# UNITED STATES PATENT AND TRADEMARK OFFICE

<b>Office Action Summary</b>	<b>Application No.</b> 10/696,448	<b>Applicant(s)</b> PENCE, CHARLES 	
	<b>Examiner</b> Jon A Szumny	<b>Art Unit</b> 3632

This is the first office action for application number 10/696,448, Method and Apparatus for Supporting a Thin, Rigid Panel, filed on October 29, 2003.

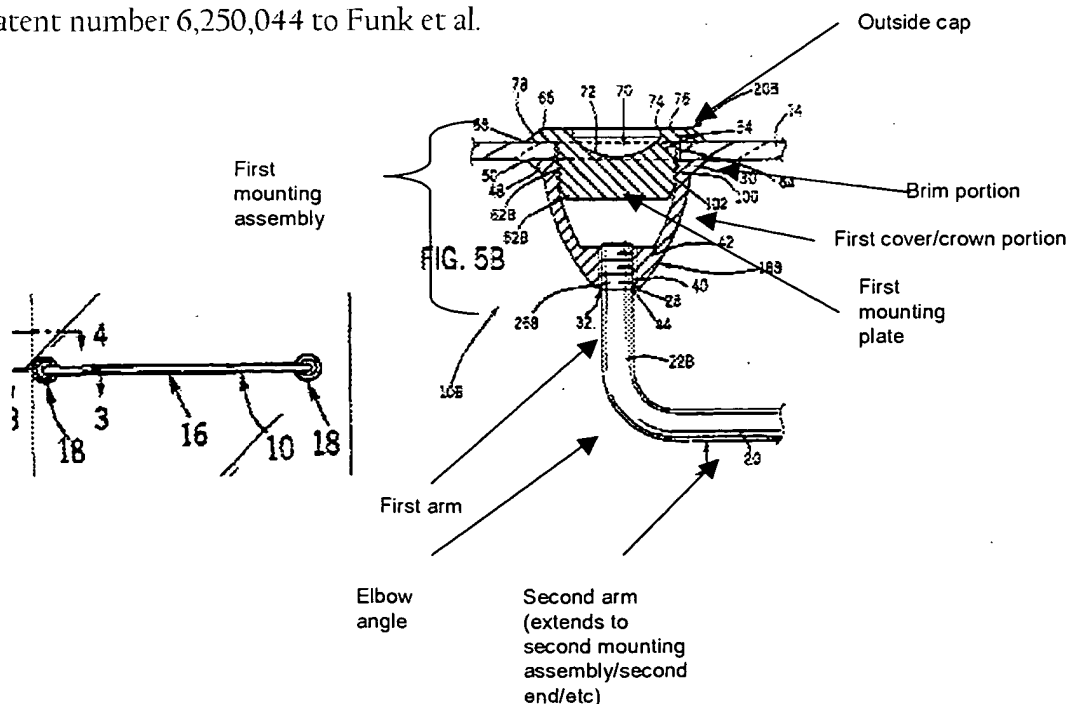
Claims 1, 2, 7, 9 and 14 are rejected under 35 U.S.C. 102(b) as being anticipated by U.S. Patent number 6,250,044 to Funk et al.

Funk et al. '044 discloses a support arm assembly (figure 1,5A) comprising a support bar (16) having externally threaded first and second ends (22,24,26) of respective first and second arms (above) joined at an elbow angle (above) nearer the first end of the first arm that is inherently substantially equal to some predetermined angle, a first mounting assembly (above) installed on the first end of the support arm, a second mounting assembly (same as first, other end) installed on the second end of the support bar, wherein the externally threaded first and second end of the respective first and second arms enable adjustment of the first and second mounting assemblies respectively along a longitudinal axis of each of the first and second arms, wherein the support bar is constructed of solid material formed into a single piece support bar, wherein the first mounting assembly comprises a first mounting plate (above), a first cover (above), and an outside cap (above), wherein the first cover comprises a top-hat-shaped cover having a crown portion (above) and a brim portion (above) and formed about a central axis, wherein a plurality of internal screw threads of pitch and diameters to match the threads around the perimeter of the first mounting plate are formed inside the crown portion (near 102), and a hole (near 32) for receiving the first arm therethrough is formed in the crown portion centered on the central axis of the first cover, wherein the predetermined angle is a right angle.

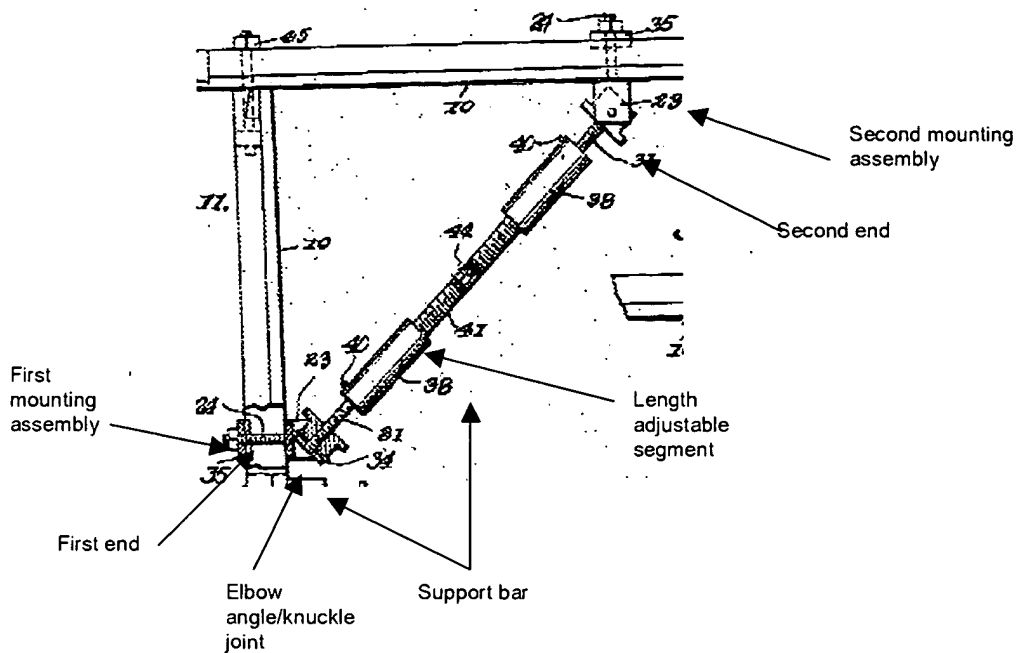
Claims 1, 3, 4, 6 and 15 are rejected under 35 U.S.C. 102(b) as being anticipated by U.S. Patent number 2,004,462 to Bush.

Bush '462 discloses a support arm assembly (figure 11) comprising a support bar (above) having externally threaded first and second ends (above) of respective first and second arms (above) joined at an elbow angle (above) nearer the first end of the first arm that is inherently substantially equal to some predetermined angle, a first mounting assembly (above) installed on the first end of the support arm, a second mounting assembly (above) installed on the second end of the support bar, wherein the externally threaded first and second end of the respective first and second arms enable adjustment of the first and second mounting assemblies respectively along a longitudinal axis of each of the first and second arms, wherein the support bar is constructed of solid material formed by two or more pieces joined together at the elbow angle, wherein the elbow angle is an adjustable angle that includes a knuckle joint having a pin at the location of the angle to enable adjustment thereof, wherein the support bar further comprises a

length-adjustable segment (above) in the second arm of the support bar, wherein the predetermined angle is other than a substantially right angle.

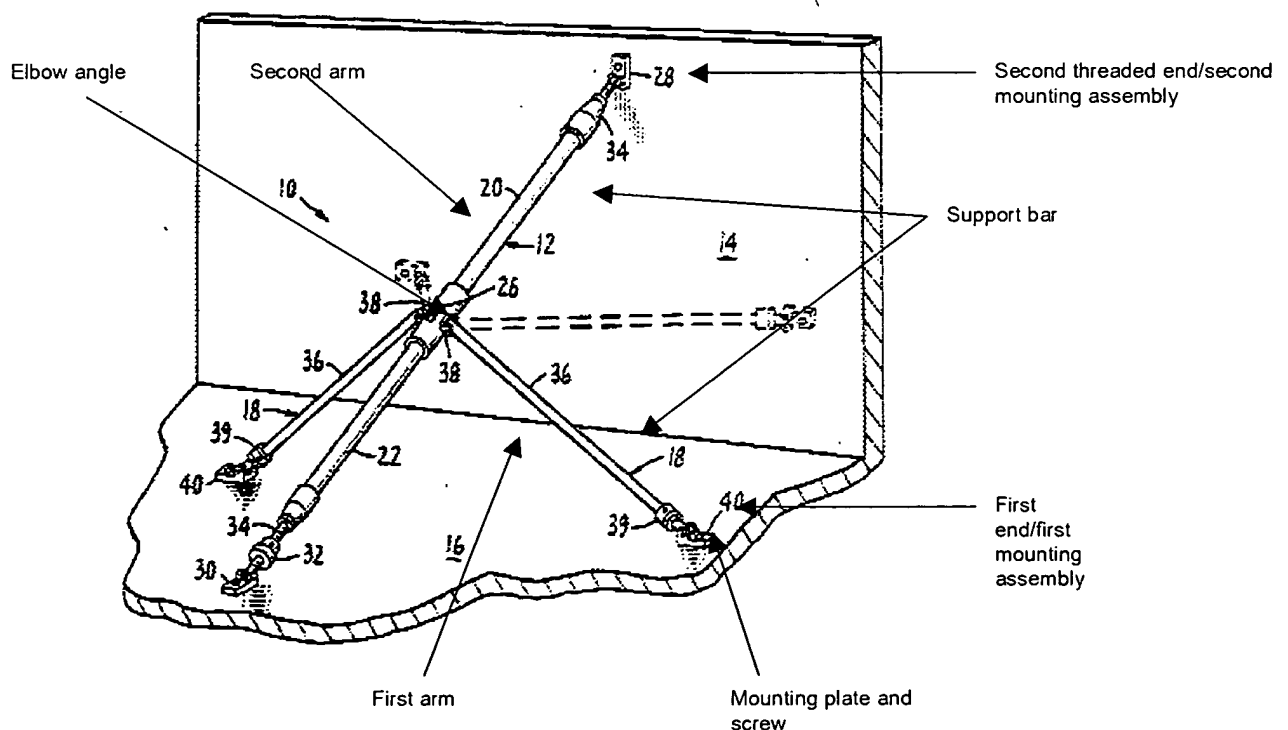
Claims 1 and 5 are rejected under 35 U.S.C. 103(a) as being unpatentable over U.S.

Patent number 4,872,634 to Gillaspy et al.

Regarding claim 1, Gillaspy et al. '634 discloses a support arm assembly (figure 1) comprising a support bar (above) having a first end and an externally threaded second end (above) of respective first and second arms (above) joined at an elbow angle (above) nearer the first end of the first arm that is inherently substantially equal to some predetermined angle, a first mounting assembly (above) installed on the first end of the support arm, a second mounting assembly (above) installed on the second end of the support bar, wherein the externally threaded second end of the second arm enables adjustment of the second mounting assembly along a longitudinal axis of the second arm. However, Gillaspy et al. '634 fails to specifically teach the first end to be externally threaded such that the first mounting assembly can be adjusted along a longitudinal axis of the first arm. It would have been obvious to one of ordinary skill in the art at the time the invention was made to have further modified the first end of the first arm to be threaded as in the second end of the second arm so as to provide for superior adjusting means of the first mounting assembly relative to the first arm, in addition to the fact that doing so would simplify the assembly process by providing for a greater uniformity of parts used.

With respect to claim 5, Gillaspy et al. '634 teaches the elbow angle to comprise a knuckle joint with a pivot pin at the location enabling adjustment thereof, but fails to specifically teach the pivot pin to be a set screw. It would have been obvious to one of ordinary skill in the art at the time the invention was made to have modified the assembly of Gillaspy et al. '634 by substituting a set screw for the pivot pin at the knuckle joint since set screws, pins, Allen screws, bolts, etc. are well known for their use
